SAN FRANCISCO PLANNING DEPARTMENT

Executive Summary Conditional Use / Residential Demolition

Date: September 7, 2017
Case No.: 2015-002653CUA
Project Address: 1016 DE HARO STREET
Zoning: RH-2 (Residential – House, Two Family) Zoning District
 40-X Height and Bulk District
Block/Lot: 4159/004
Project Sponsor: Marc Dimalanta, D-Scheme Studio
 222 8th Street
 San Francisco, CA 94103
Staff Contact: Esmeralda Jardines – (415) 575-9144
esmeralda.jardines@sfgov.org
Recommendation: Approval with Conditions

Shadow cast from a 4 story (40ft building)

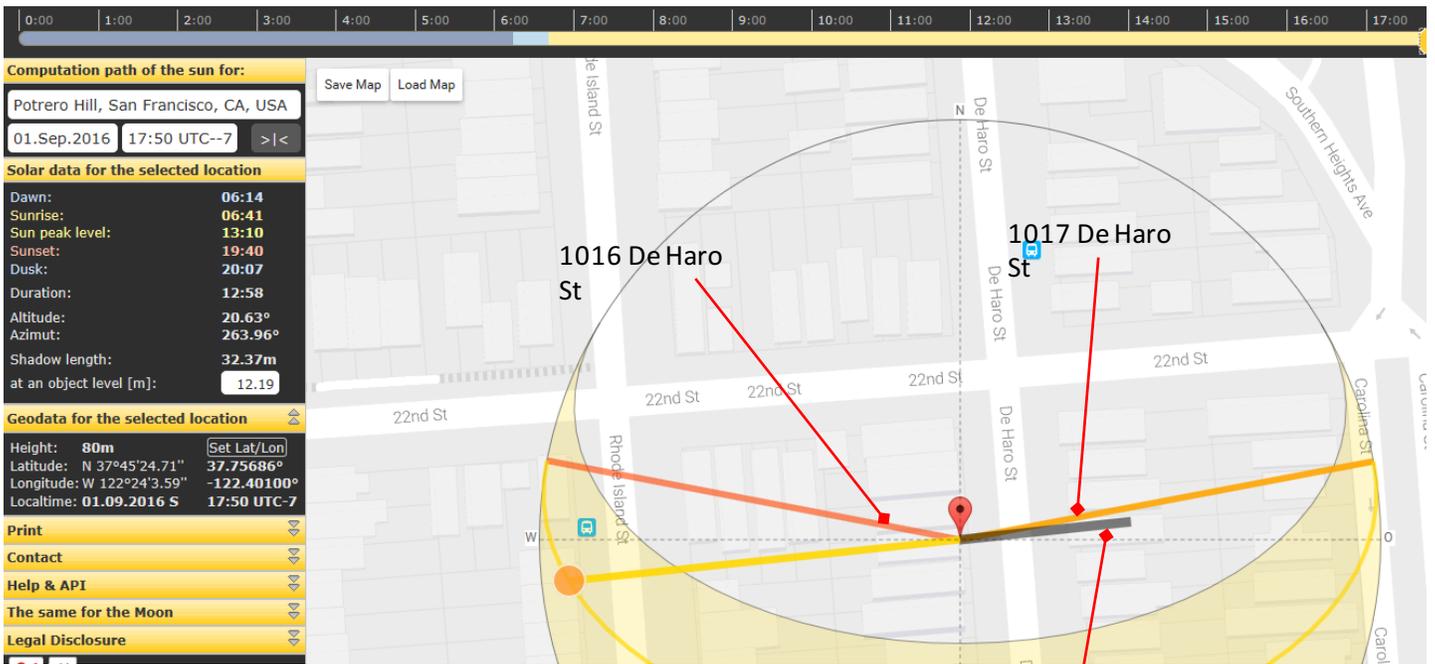
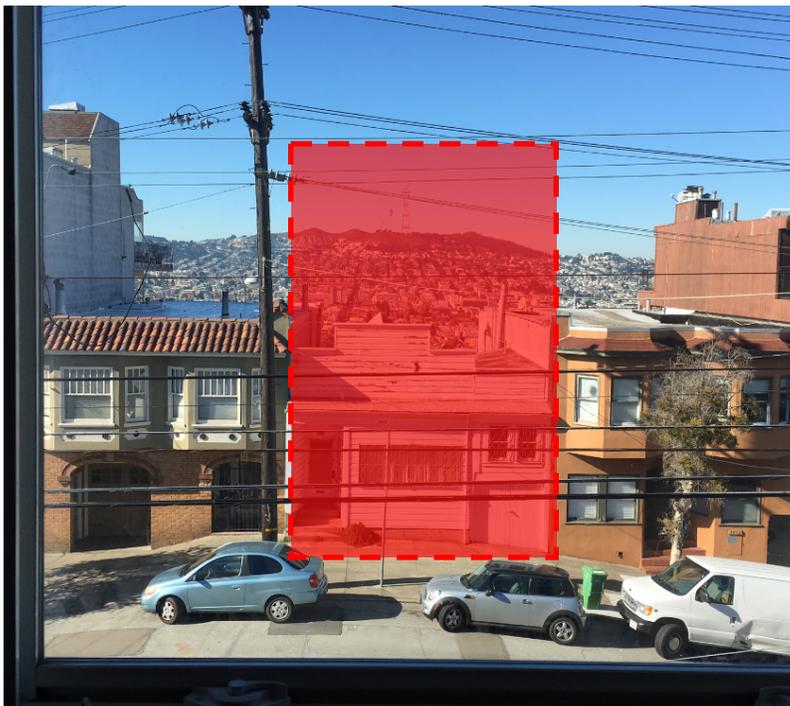
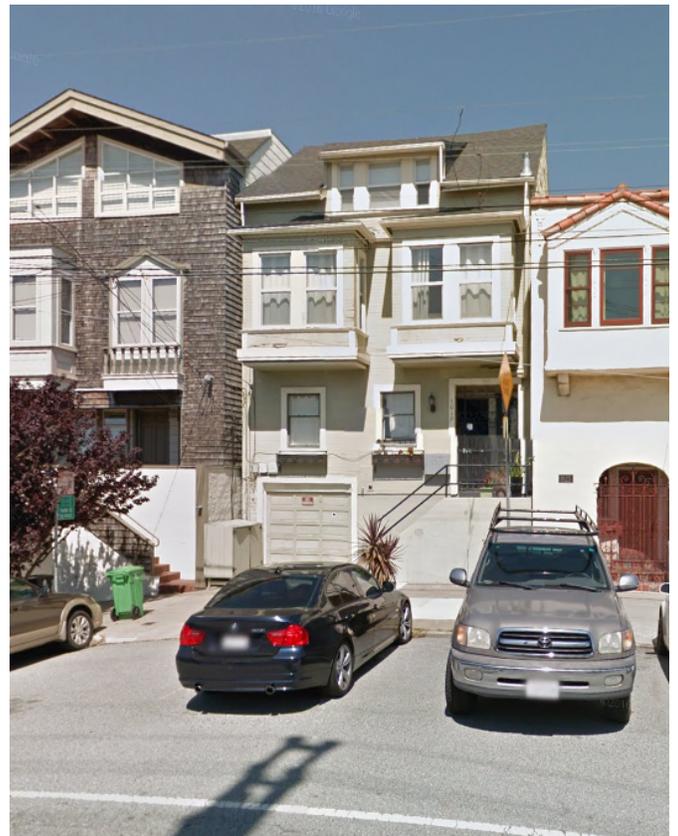
3. De Haro St is a narrow road, and my building stares directly facing this site. The current proposal will act as a shield and barrier to natural light and be a severe eye sore, dominating the space and making occupants in my building feel claustrophobic. In addition to the imposing feel, from running a shadow study, the building blocks natural light from entering the buildings across the street.

The proposed 1016 De Haro building proposal will engulf the all of the outward facing windows in shadow

Windows face directly to 1016 De Haro

Current Plan

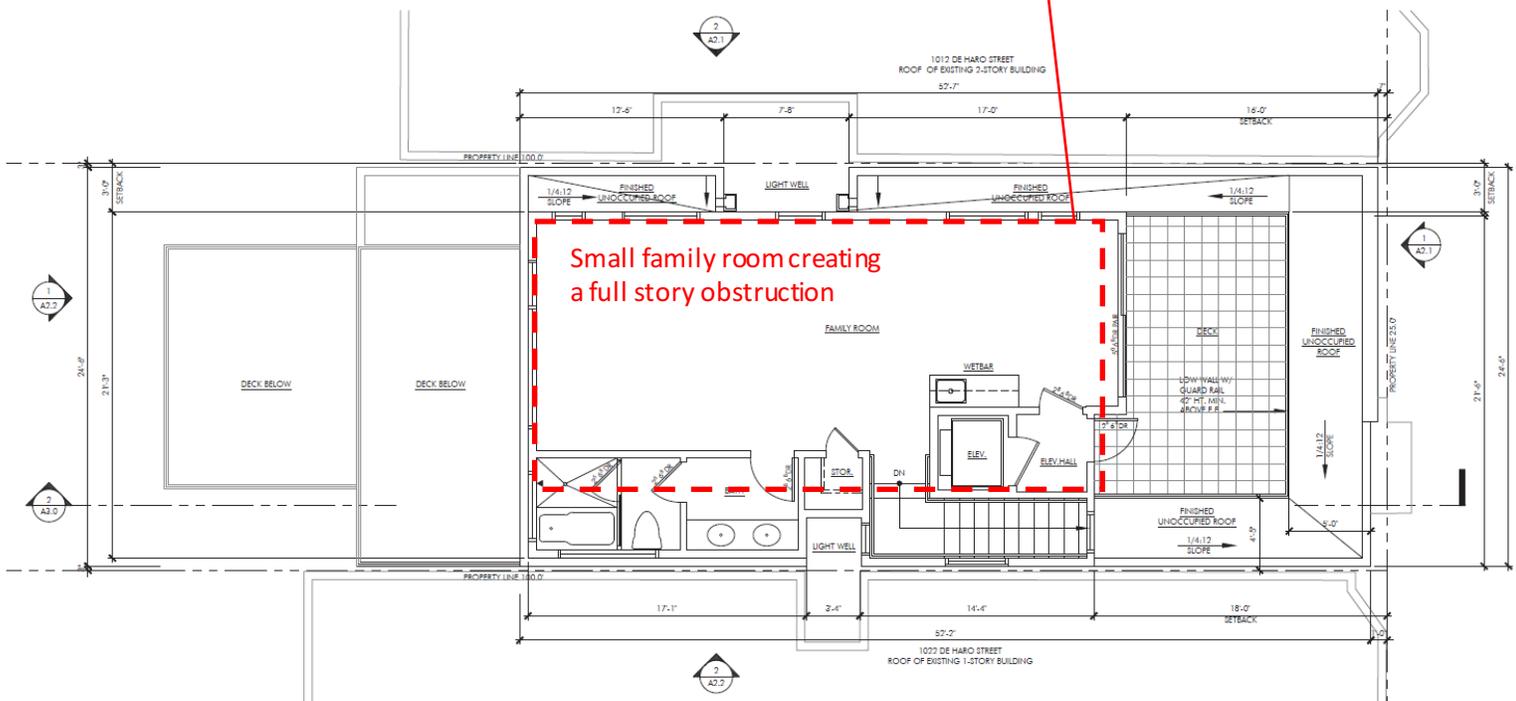
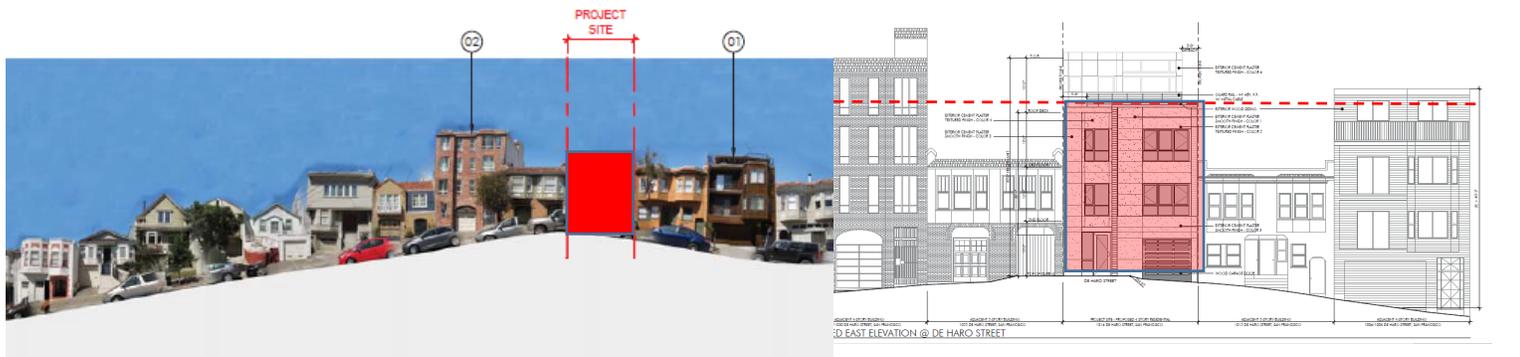
Minor value additions causing major blockage issues

- Top floor is a very small sq foot area, having minimum gain for a building with already a very large amount of sq footage for its usage, but has a huge impact on the surrounding building (approx. 8% sq footage adder)
- 4 car elevator was reduced to a 2 car garage adding square footage, but no reduction was made in removing the top floor cap.
- After the last hearing, the commission asked that the owners work with the neighbors and make compromises with one another, specifically pertaining to the top floor.
- There were a few asked to make the plans more acceptable to the use and neighborhood., but the plans remain virtually identical from the initial submission.

As a community, we ask that we come to an agreement that works for both, and not take an approach that over indexes on individual gain

Mutual compromised suggestion for owner

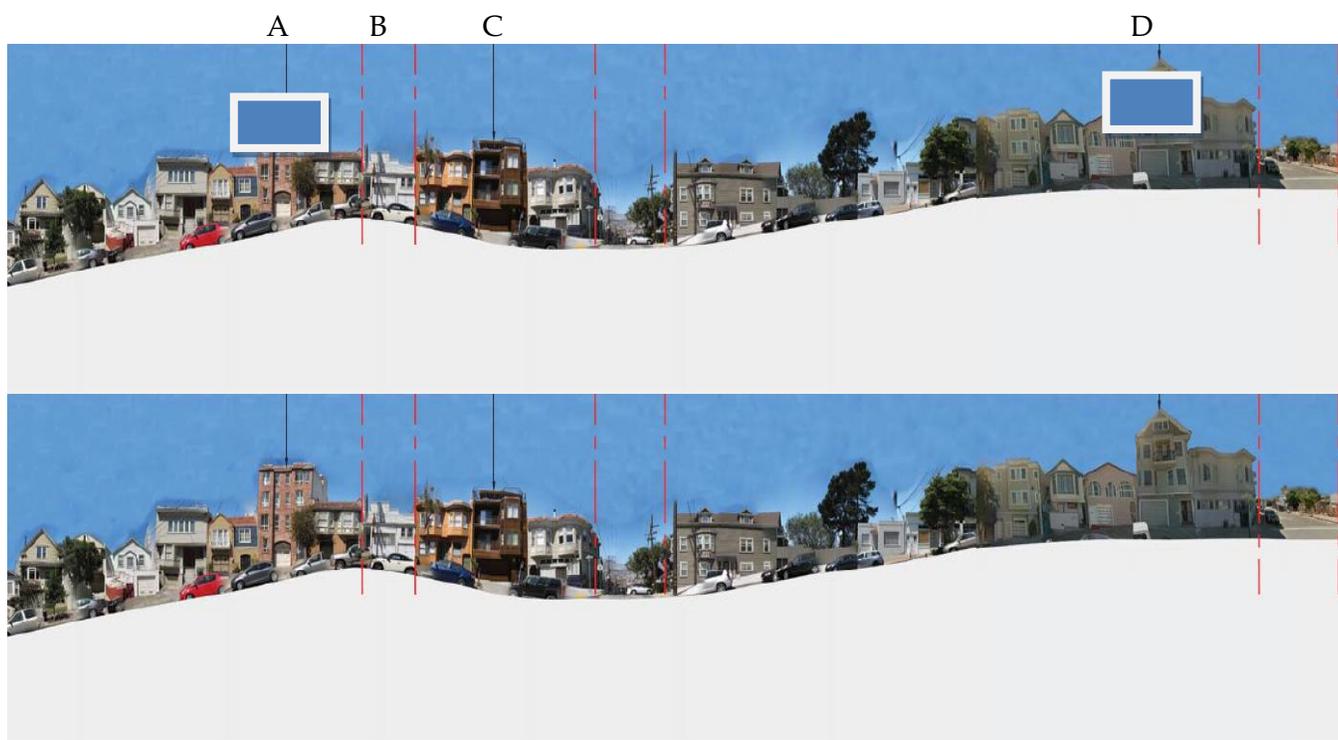
The images below show another look at the profile of De Haro Street. Notice when the buildings at locations “A” and “D” (the two “outliers” represented by blue boxes) are removed, there are no structures that look out of place. This profile presents a neighborhood with a mixed visual style, yet no building seems to overpower the skyline. I am concerned that by adding a four story building at location “B”, the crest of the hill, will add an **overpowering structure that will serve to negatively impact the aesthetics and character of that block**. I ask that you please review the proposed building at 1016 De Haro to determine if there is **some way to reduce the overall height of that building to bring it more in line with the profile of the existing homes on that street**.

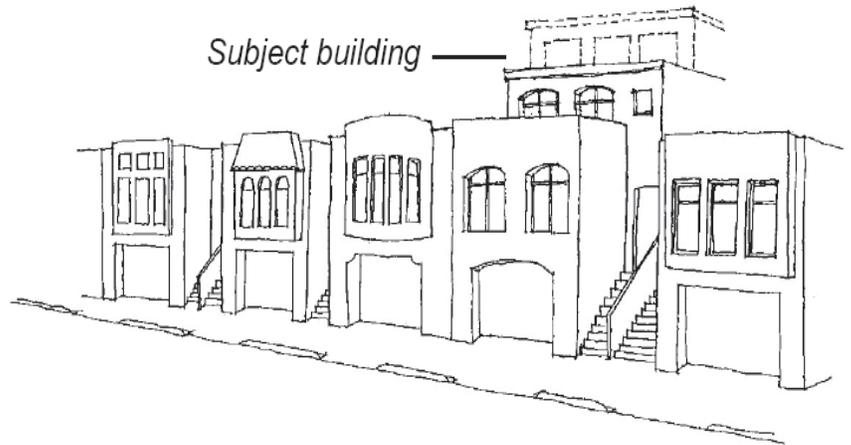
I have compared the original set of plans included in the Executive Summary dated 31 October to the latest set of plans I have seen from January 2017. **I see very minimal changes to the design** other than to: 1) remove the open deck on the 4th story (but not the "family room" structure) - doing this does nothing to reduce the mass and height of the building; 2) eliminate one parking space (but I don't see where that leads to any additional livable space as the stacker remains); and 3) alter the naming of the family room on the 4th story to "family room, children's study area and toddler's study and play area." There was no change in the size of the family room.

I am not an architect, so if my interpretation is incorrect, I apologize in advance. I was unable to attend the meeting the sponsors held in late May as I was not notified (they sent the notification to my rental property and not my home address). Two of my neighbors attended the meeting, and their impressions concur with my understanding of the minimal changes made. I have emailed the sponsor to ask for his list of changes to compare with what I see, but I have not received a reply.

I don't believe the minimal changes made to the design address the spirit of the questions and issues raised at the 10 November hearing. The hearing has been delayed several times, thus I believe the architect and sponsors have had ample time to make a good faith effort to address our concerns. I find this disappointing.
